ROUTE 7 CORRIDOR IMPROVEMENTS

State Project Nos.: 0007-029-942 and 0007-028-225
Federal Project Nos: STP-5A01(745) and STP-5A01(790)
Contract ID No.: C00099478DB98

VOLUME I: REVISED TECHNICAL PROPOSAL

Summary of Changes

STATE	ROUTE	PROJECT	SHEET NO.
VA.	7	0007-029-225 P101, R201, C501 0007-029-942 P101, R201, C501	3

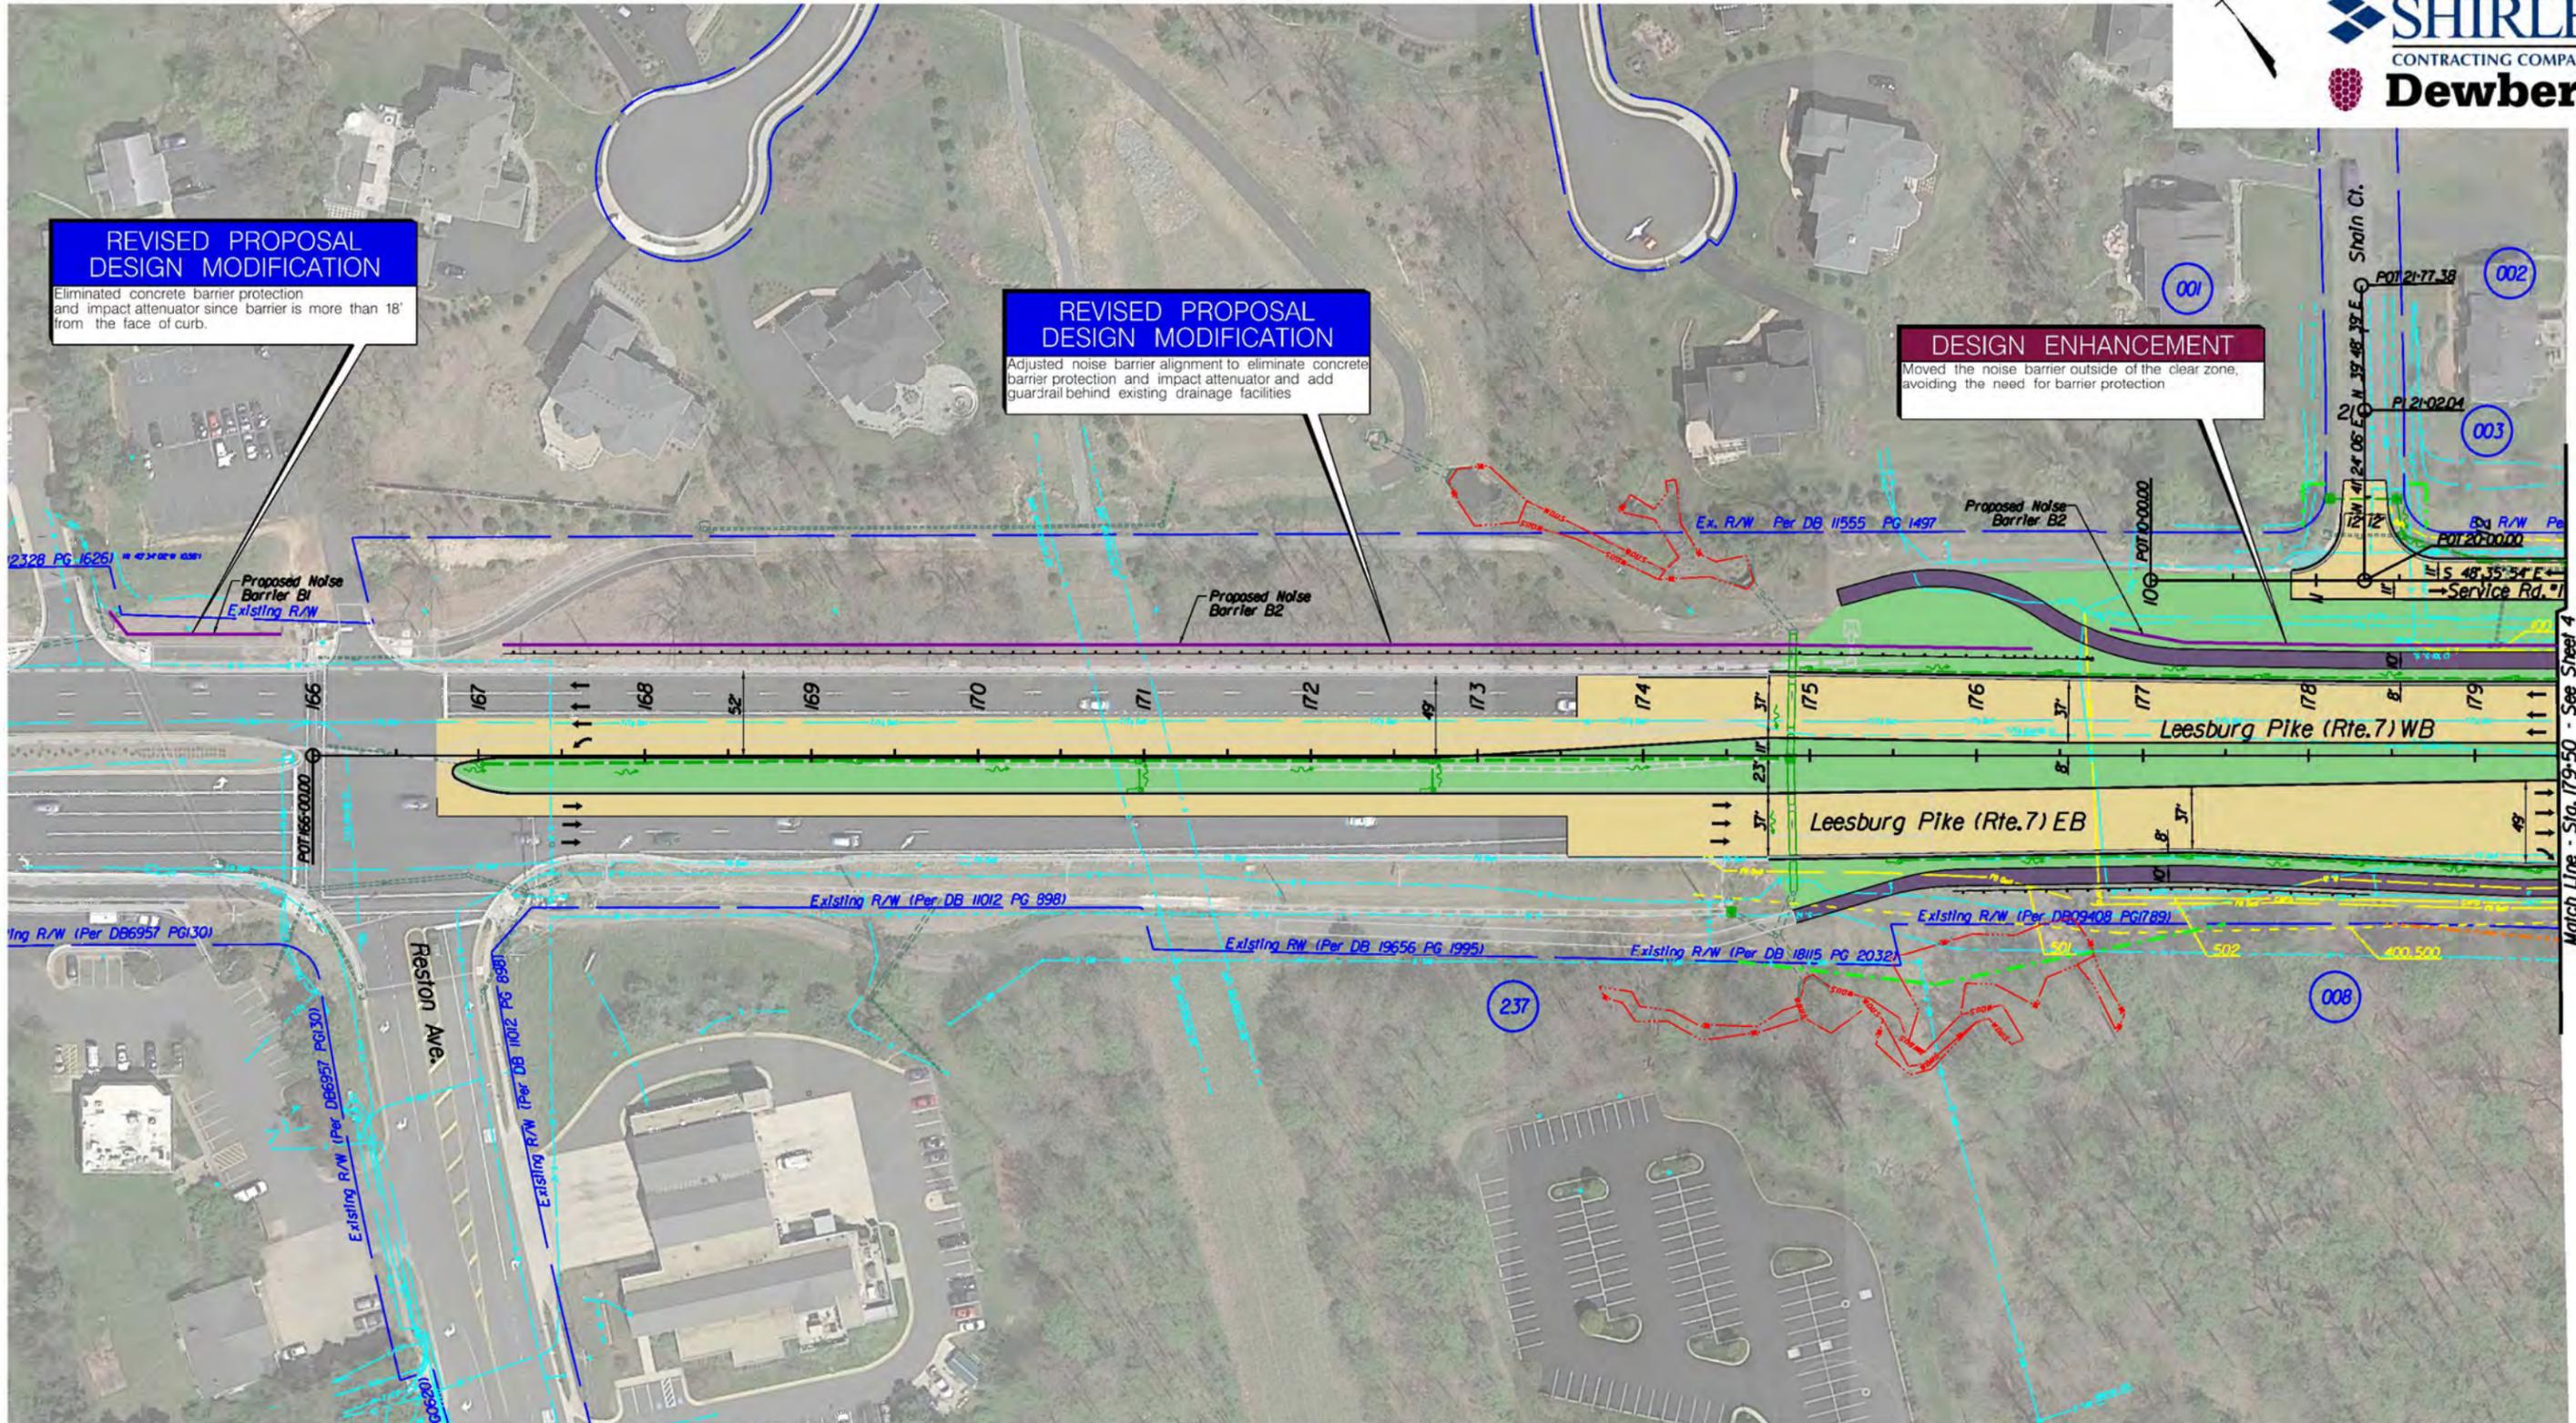
REVISED PROPOSAL DESIGN MODIFICATION
Eliminated concrete barrier protection and impact attenuator since barrier is more than 18' from the face of curb.

STATE	ROUTE	STATE PROJECT	SHEET NO
VA.	7	0007-029-225 P101, R201, C501 0007-029-942 P101, R201, C501	10

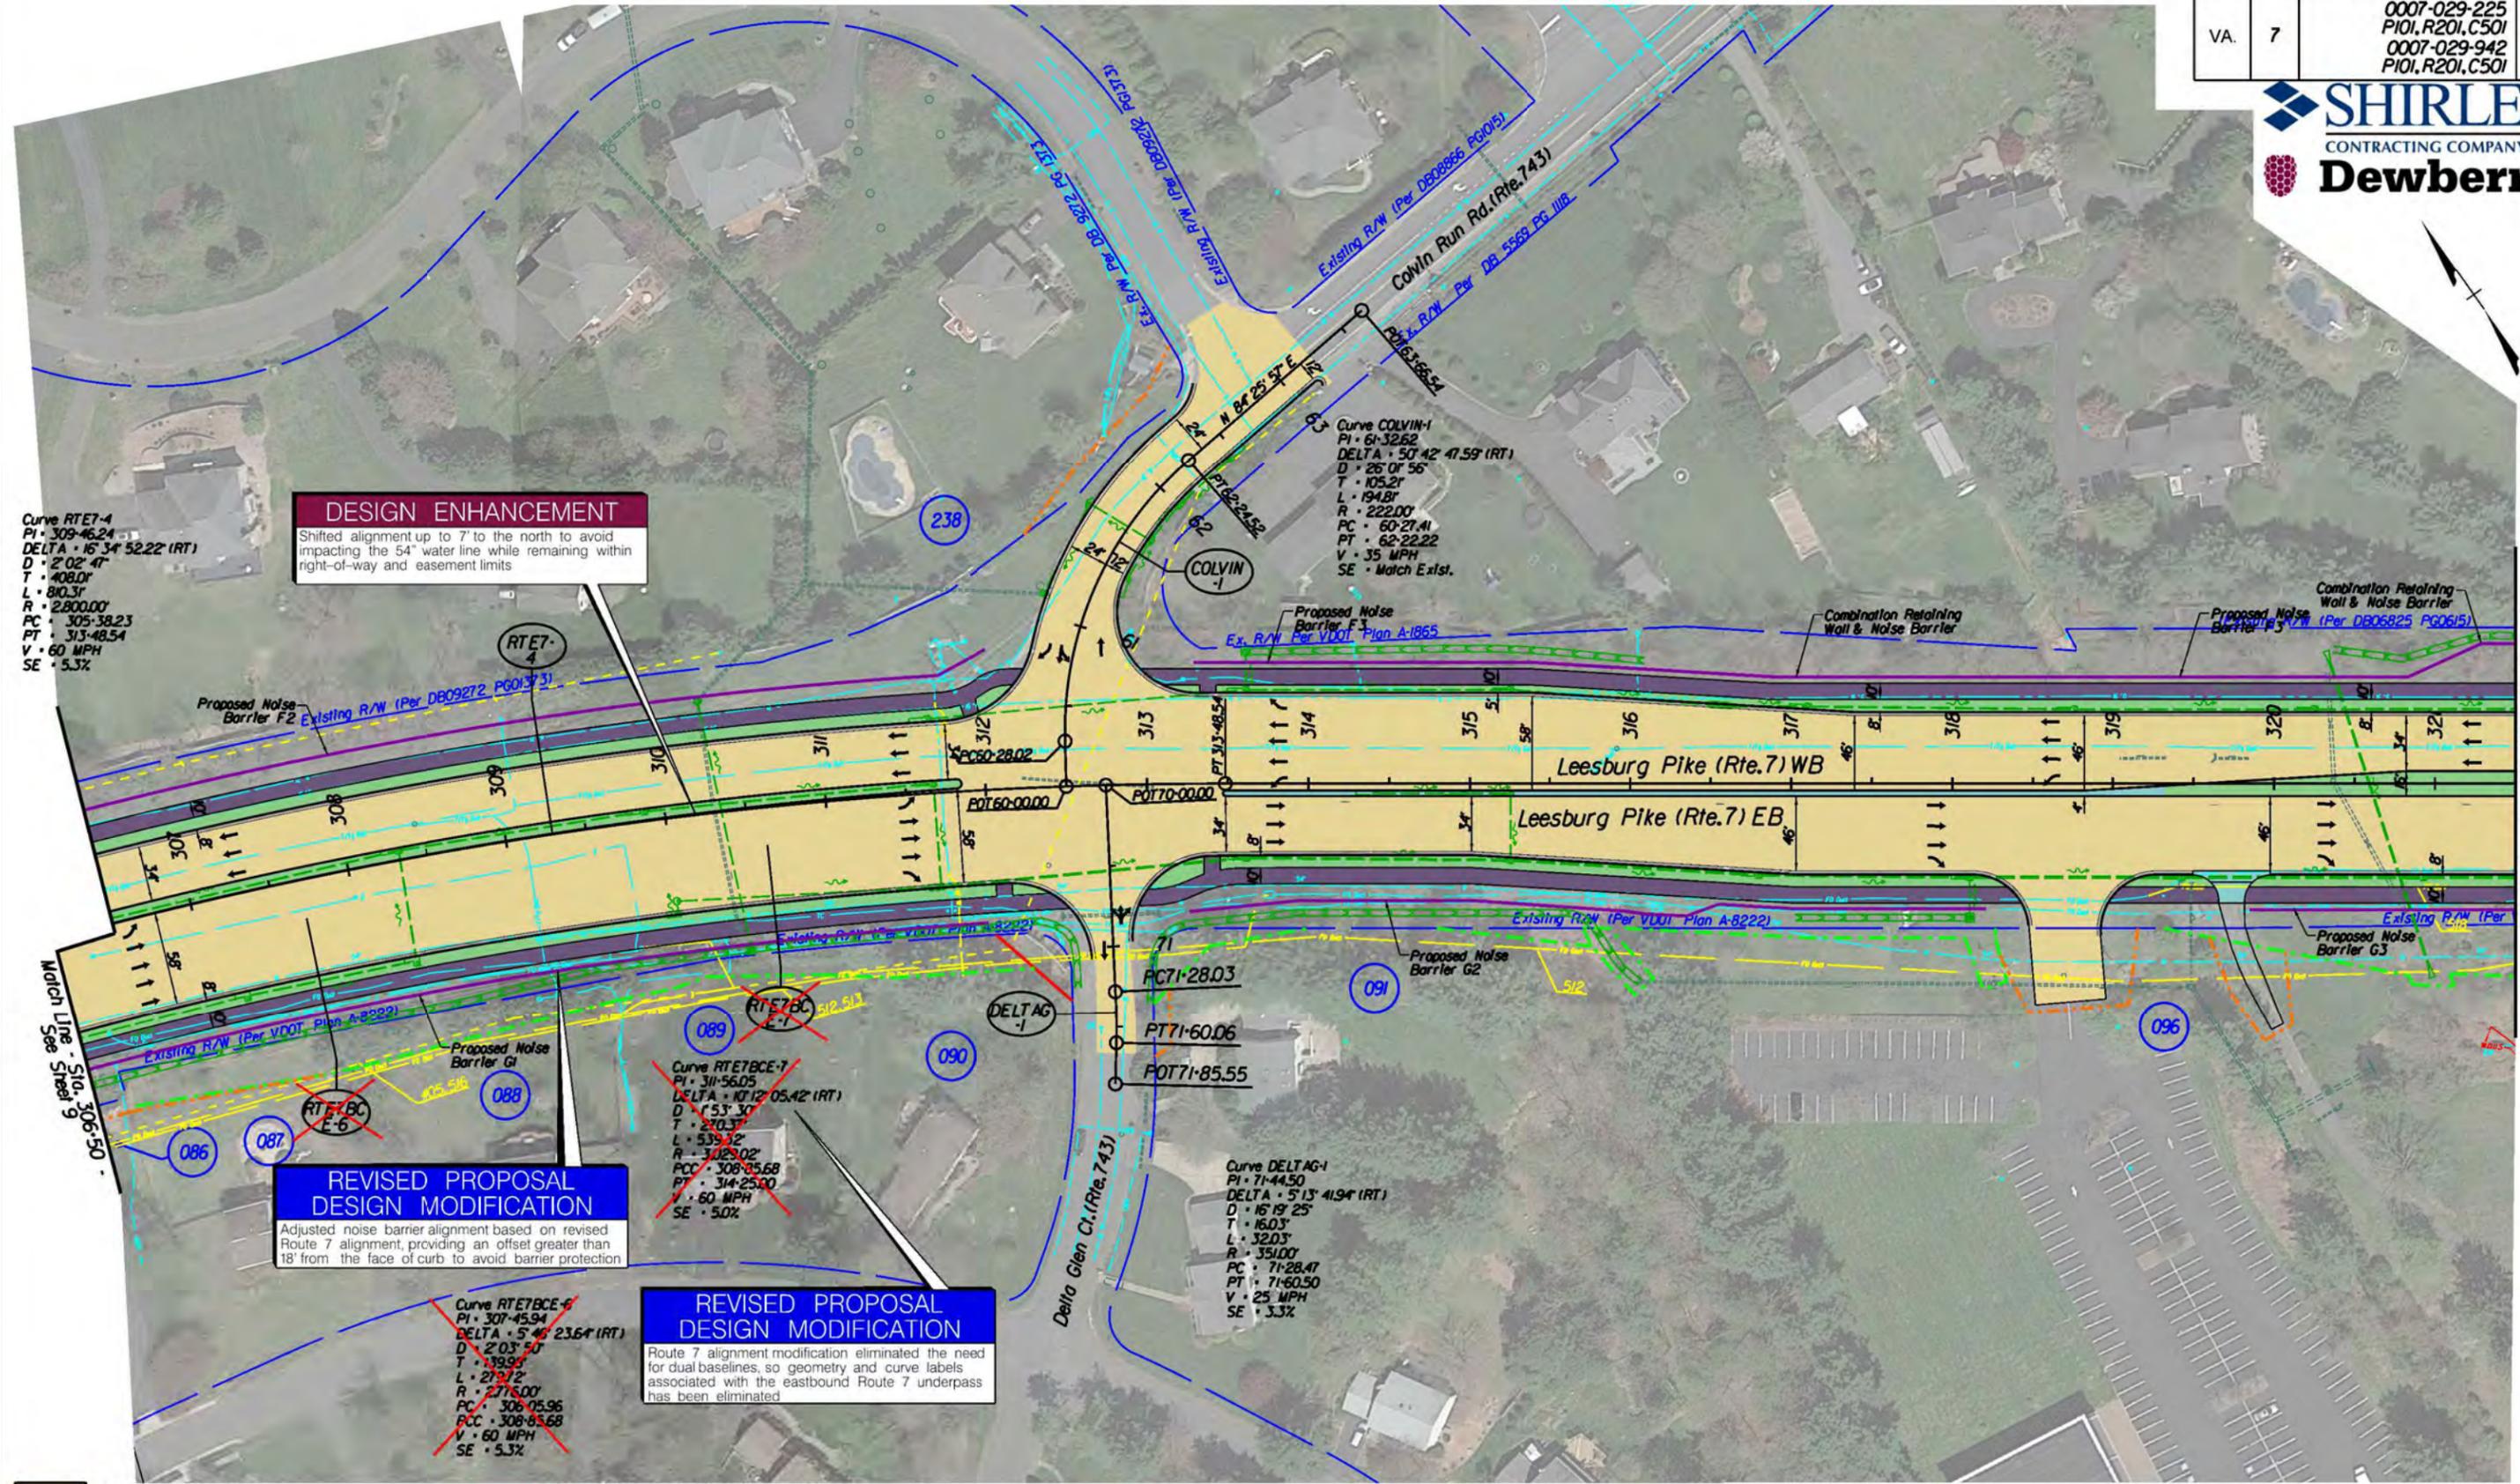
DESIGN ENHANCEMENT
 Shifted alignment up to 7' to the north to avoid impacting the 54' water line while remaining within right-of-way and easement limits

STATE	ROUTE	STATE	SHEET NO.
		PROJECT	
VA.	7	0007-029-225	13
		PI01, R201, C501	
		0007-029-942	
		PI01, R201, C501

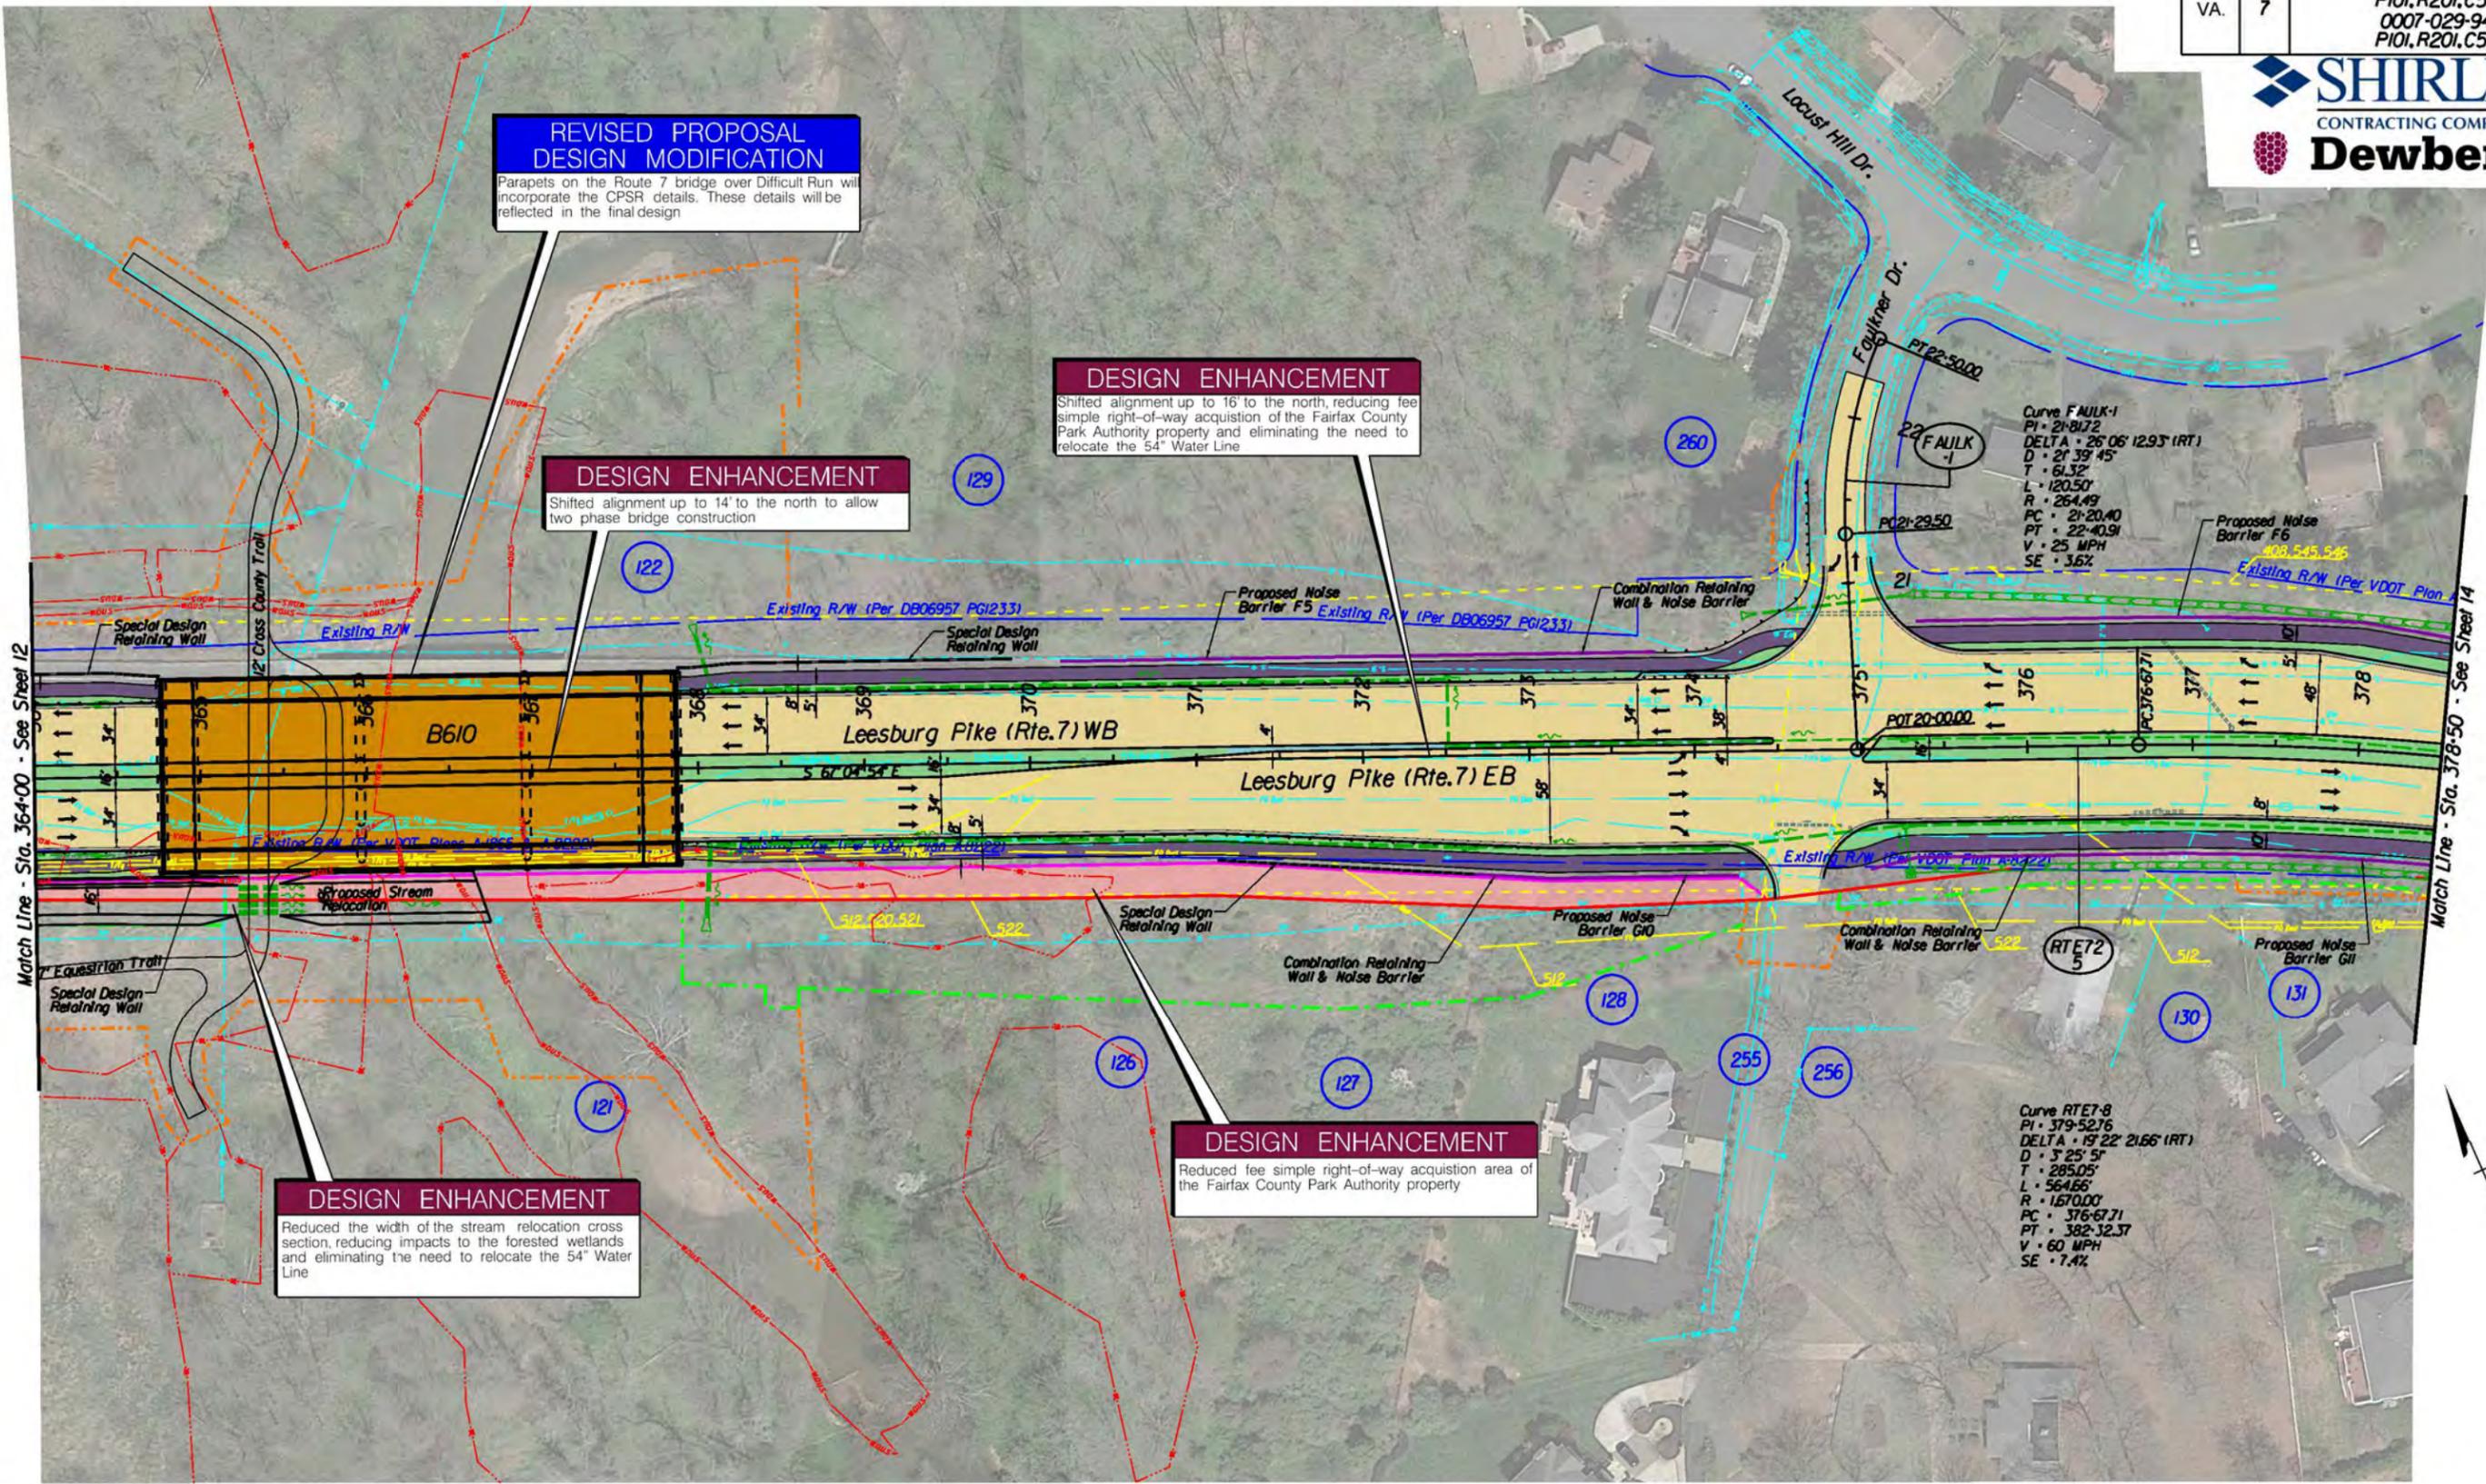
REVISED PROPOSAL DESIGN MODIFICATION
Parapets on the Route 7 bridge over Difficult Run will incorporate the CPSR details. These details will be reflected in the final design
